Assessment Officer Report

PA2302327

Lot 27 Hot Plate Drive, Hotham
Heights

Officer Assessment Report
Development Approvals & Design

Figure 3 – Snow shed plan (Source: Application)

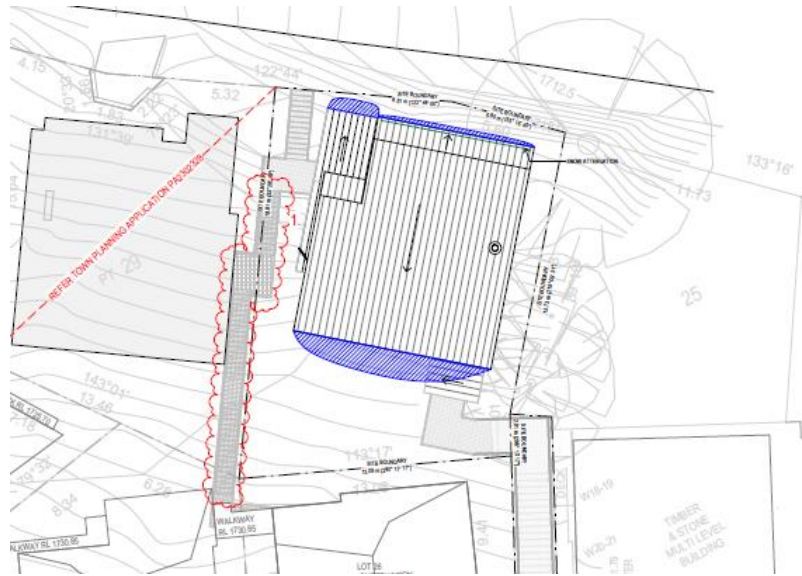
- The 'snow management plan' (Drawing No. TP109 and Figure 3) shows the roof will be provided with a snow retention beam. The plan also shows the designated 'snow dump area' where snow will fall from the roof, showing all snow dump will be contained within the sub-lease boundaries.
- The proposed roof has a shallow pitch of 9 degrees with the fall towards the south, which will slow snowfall across the roof and direct it away from walkways, with the exception of a small roof above the entry at Level 1. A small verandah section of the main roof will also have a 25 degree pitch to the north.

35. In terms of snow shedding, the plans show that the roof of the proposed dwelling will be provided with a snow retention beam. The snowshed mainly falls towards the rear of the dwelling, away from areas frequented by occupiers and guests, with the exception of the proposed entry, which is roofed. Furthermore, the snow dump areas will be contained within the sub-lease boundaries of the site. Snow shed areas will not be used by occupiers or guests as no access is provided to these areas. Furthermore, the steep terrain will prevent access to the snow dump areas by persons.
36. A note will be placed on the permit regarding the need to obtain a building permit, including all requirements for snow retention on the roof.

Figure 4 – Tree removal plan/location (Source: Application)

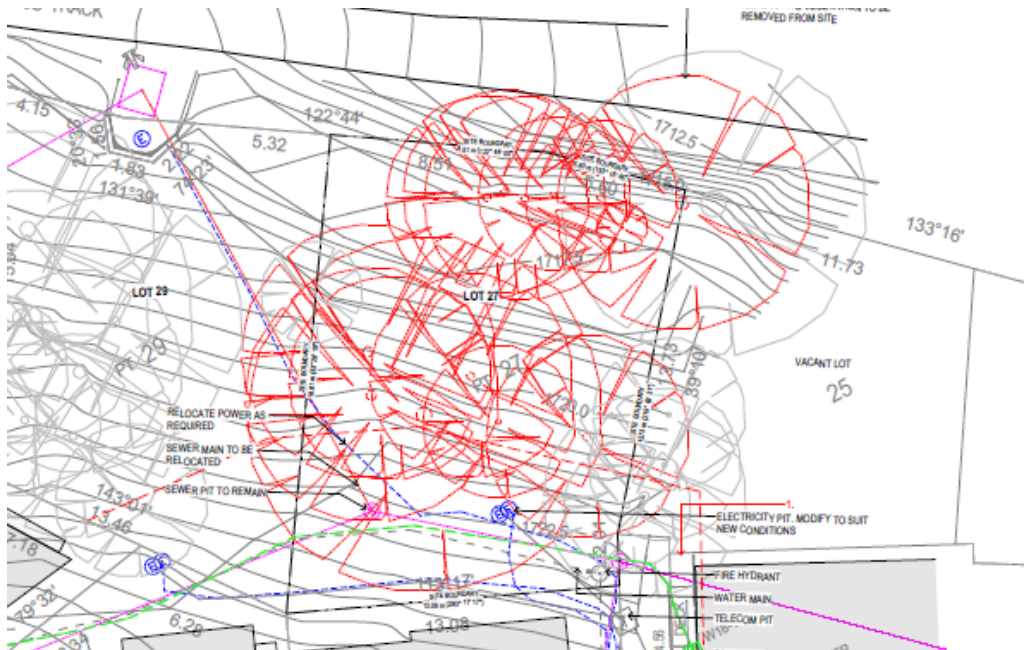
- It is proposed to remove 0.026ha of native vegetation, including 2 large trees.

42. It is proposed to remove 0.026 hectares of native vegetation, comprising of EVC 43 patch vegetation, including seven trees. Two large trees within the patch are being removed, which fall within development footprint. 0.034 species habitat units for Woolly Billy-buttons, *Craspedia maxgrayi* s.s., including the protection of at least two large trees is required as offsets.

43. The application was referred to DEECA, who have the delegation from the Secretary to the Department of Environment, Energy, and Climate Change (as constituted under Part 2 of the Conservation, Forests and Lands Act 1987). DEECA do not object to the proposal and have included conditions to offset the removal of 0.026ha of native vegetation and for the evidence to be provided prior to the removal of any vegetation. Other conditions to be included will ensure good practices are adhered to during construction and vegetation to be retained is well protected.
